BOROUGH OF HIGHLANDS LAND USE BOARD REGULAR MEETING

AGENDA

- 5. LUB25-02: Kubis 260 Navesink Ave., B119 L2.01
- 6. LUB25-10: Solar Powered 44 44 Miller St., B58/7.01

SITE PLAN SCALE: 1" = 20'-0 INFORMATION SHOWN ON THIS PLAN
IS BASED ON SURVEY DONE BY:
THOMAS CRAIG FINNEGAN
PROFESSIONAL LAND SURVEYOR
N.J. LIC. No. 38601
DATED 01/13/23.

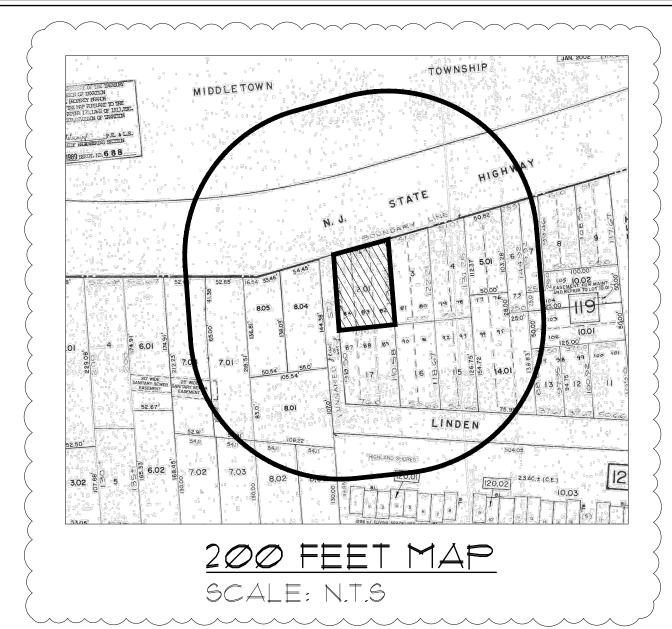
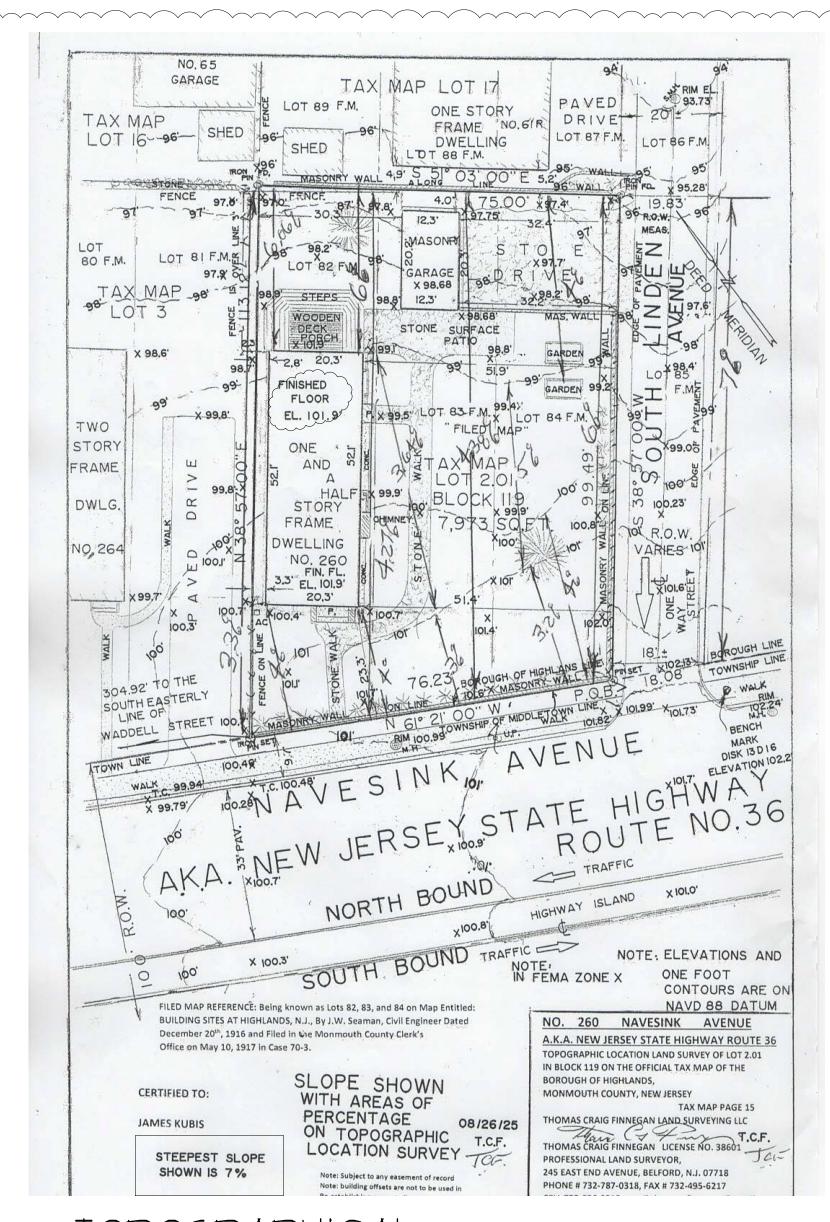
Please update the zoning data table. The minimum side yard is noted as 2.8 ft., however the plan states 2.3 ft.

- 3. There are no rear yards for corner lots. According to §21-8 Definitions. Please update the zoning data table.
- 4. A variance appears to be required for the proposed deck. Please provide dimensions and confirm. Please refer to § 21-65.27.
- 5. A variance is required for the lot depth.
- 6. Please provide the building height according to § 21-8.
- 7. There are two decks proposed for the lot. One is a proposed flat deck located above a rear portion of the first story of the existing dwelling with a proposed stairway to a lower proposed ground level wood deck. The Applicant has indicated that the wood deck is replacing an existing deck.

According to the Architectural plans the proposed wood deck is much larger (length and width) than the existing deck and requires footings.

Please provide the 3 ft deck setback lines.

Please provide the two side yard setback dimensions to the proposed wood deck.

The zoning data table on the plans shall be revised accordingly. Include a deck category on the zoning data table.
